Office Action Summary

10/571,996

MATSUMURA ET AL.

DETAILED ACTION

- Modified figure 1 -

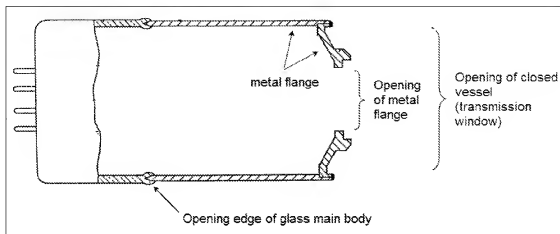
Regarding claims 12 and 17, Kutsuzawa teaches an apparatus comprising a closed vessel (30) including an opening (see right hand side of figure 1) for defining a transmission window and having a glass main body (31) which has an opening edge (see modified figure 1 below), a metal flange (32 and 36; it is noted that flange is defined as a projection for attachment to another object) attached on the opening edge of the main body and having an opening

It would have been obvious to one having ordinary skill in the art at the time of the invention to replace the intermediate film (39) and window (37) of Kutsuzawa with the window of Karnezos et al. such that at least a part of the glass faceplate is attached to the metal flange while the center of the opening of the glass faceplate corresponds to the center of the opening of the closed vessel since one would have been motivated to make such a modification to provide a window for soft x-rays that can be used to detect light elements such as hydrogen or oxygen (col. 1, lines 50-59) as implied by Karnezos et al. '490.
